RAVENCLIFF-MCGRAWS-SAULSVILLE PUBLIC SERVICE DISTRICT WYOMING COUNTY, WEST VIRGINIA

PROPOSED CONTRACT #2 – NEW RICHMOND WATER TANK

NOVEMBER 1, 2018 ADDENDUM #3

RAVENCLIFF-McGRAWS-SAULSVILLE PSD SHEET No.
PROPOSED WATER TANK 2

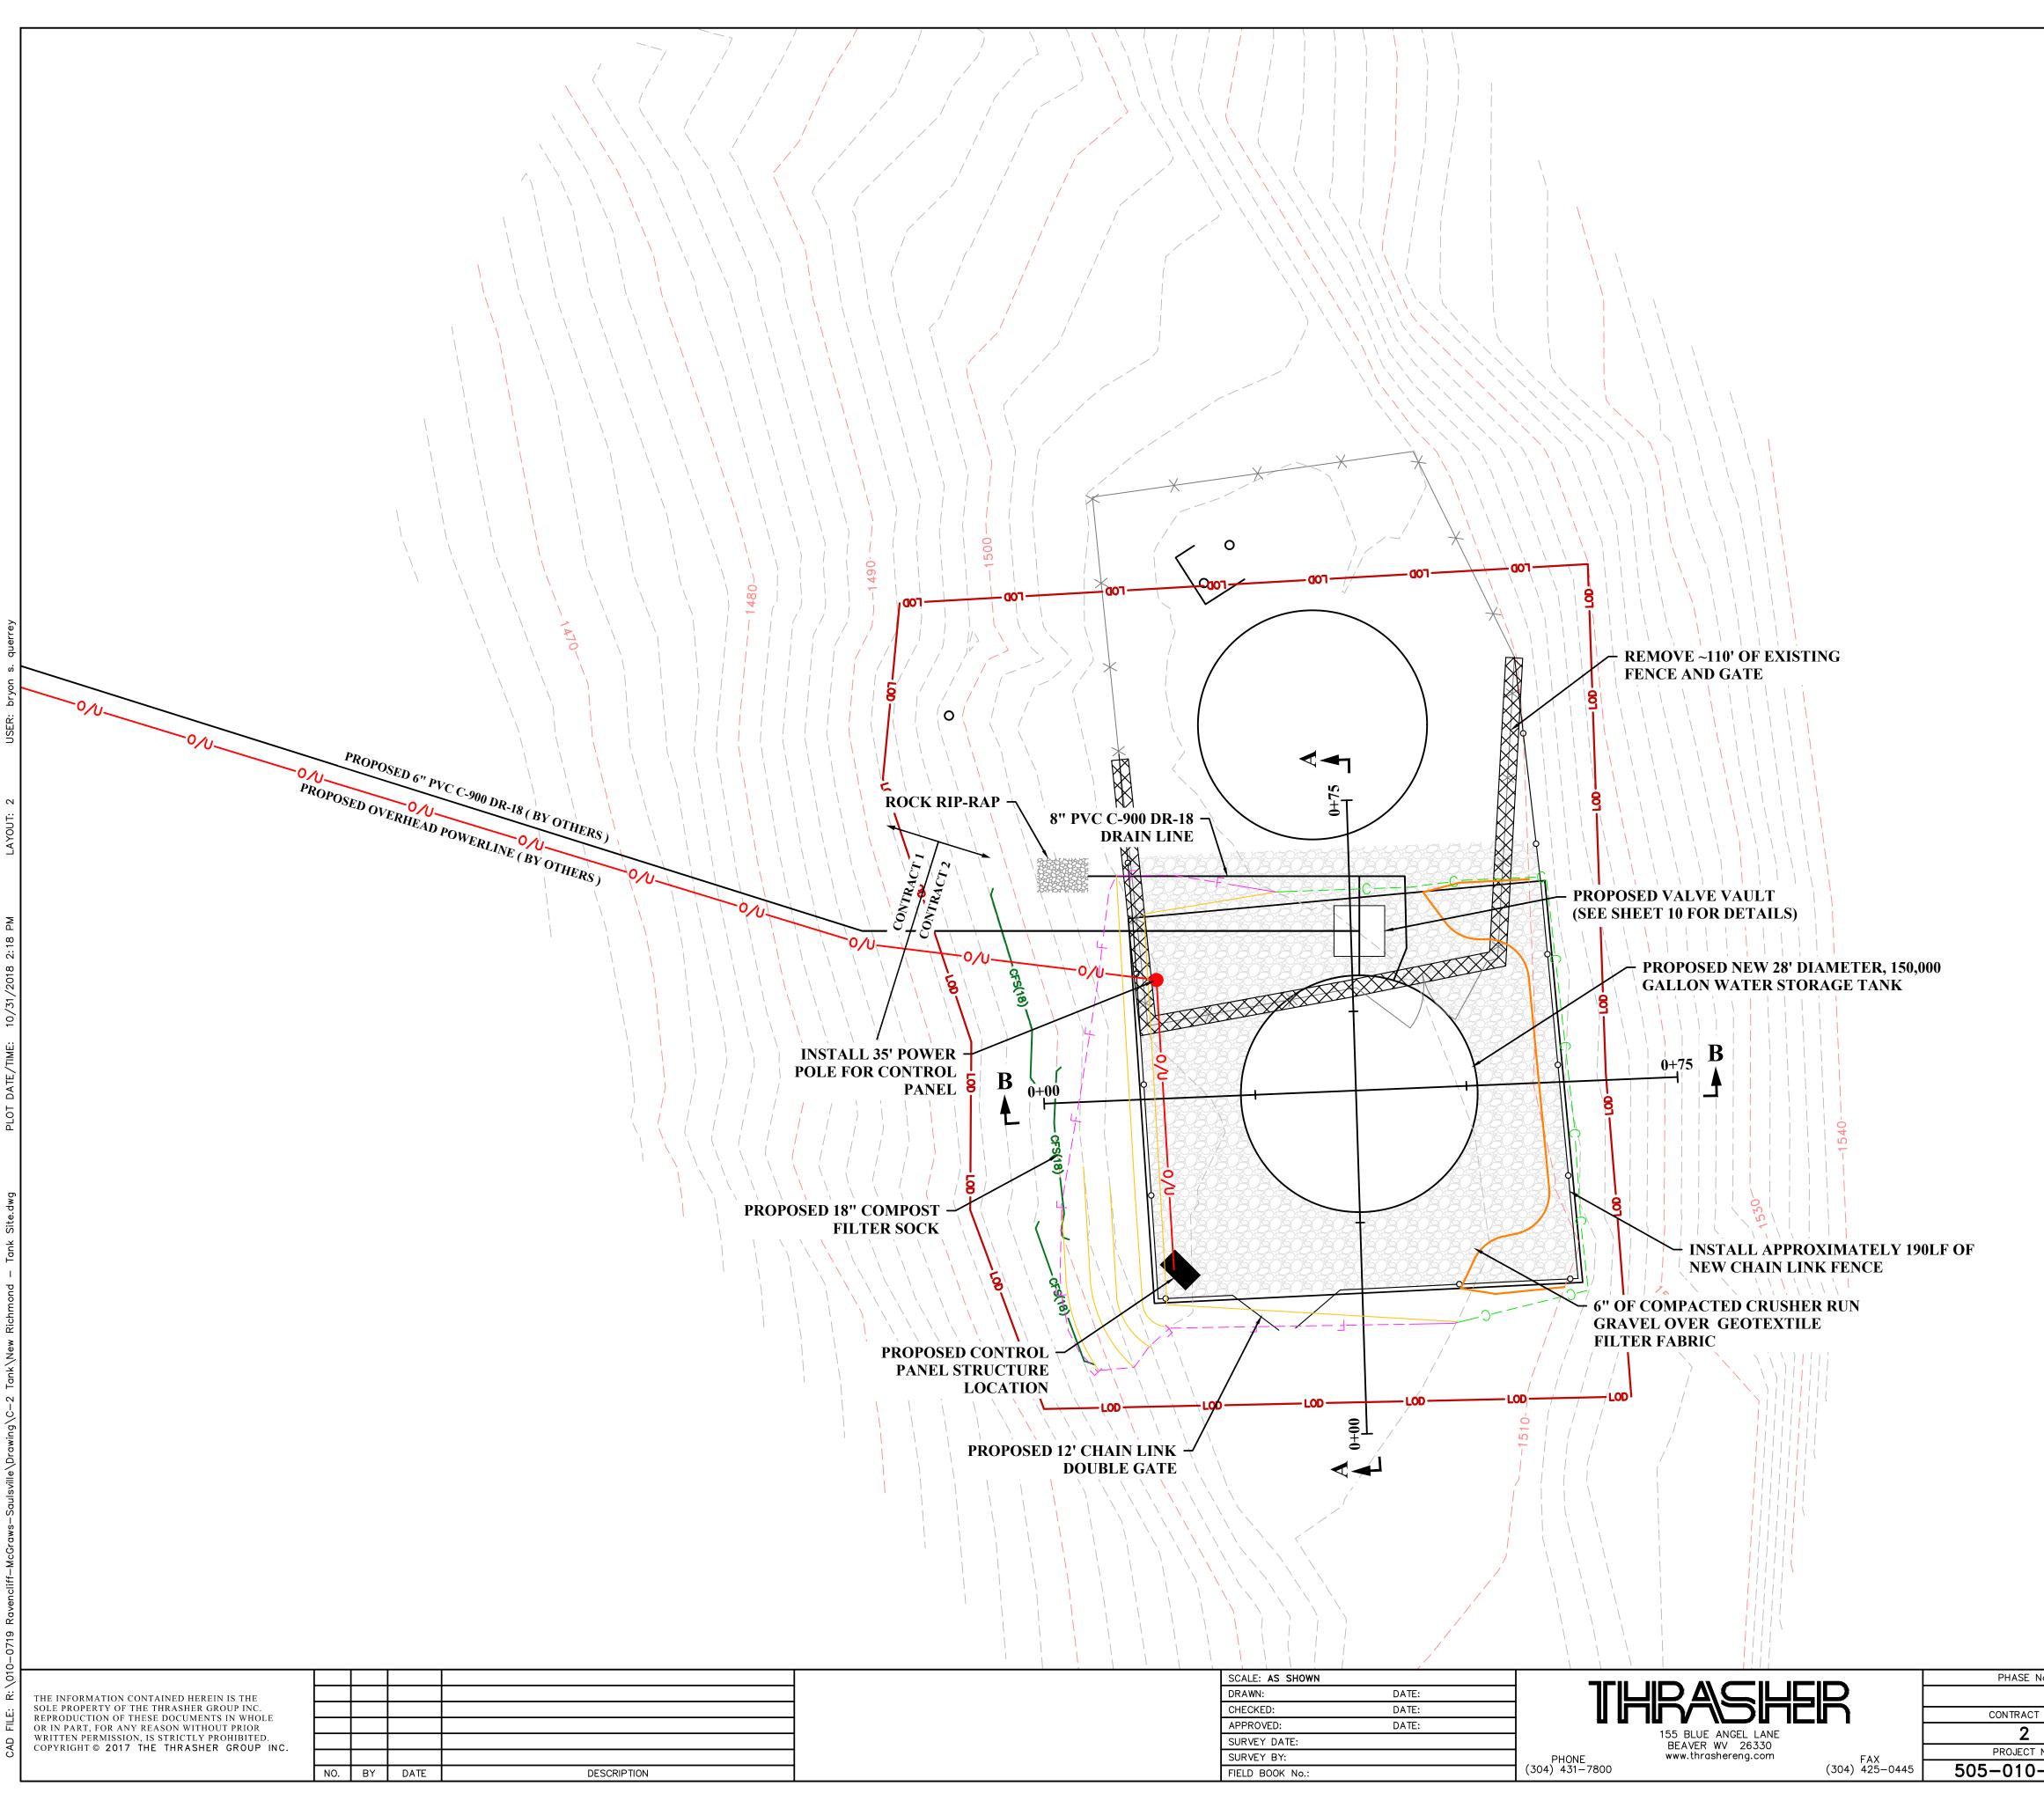
1. **DISREGARD** previous versions of Plan Sheet 2 and **REPLACE** with the attached version of Plan Sheet 2.

Some of the tank cross sections show 6" gravel around the tank, but the extent of the gravel isn't indicated on the plan view. How big of an area is to receive gravel?

Approximately 1,910 square feet of the site will receive geotextile fabric and six (6) inches of gravel. Please see the attached revised Plan Sheet Number 2 for the location of the gravel.
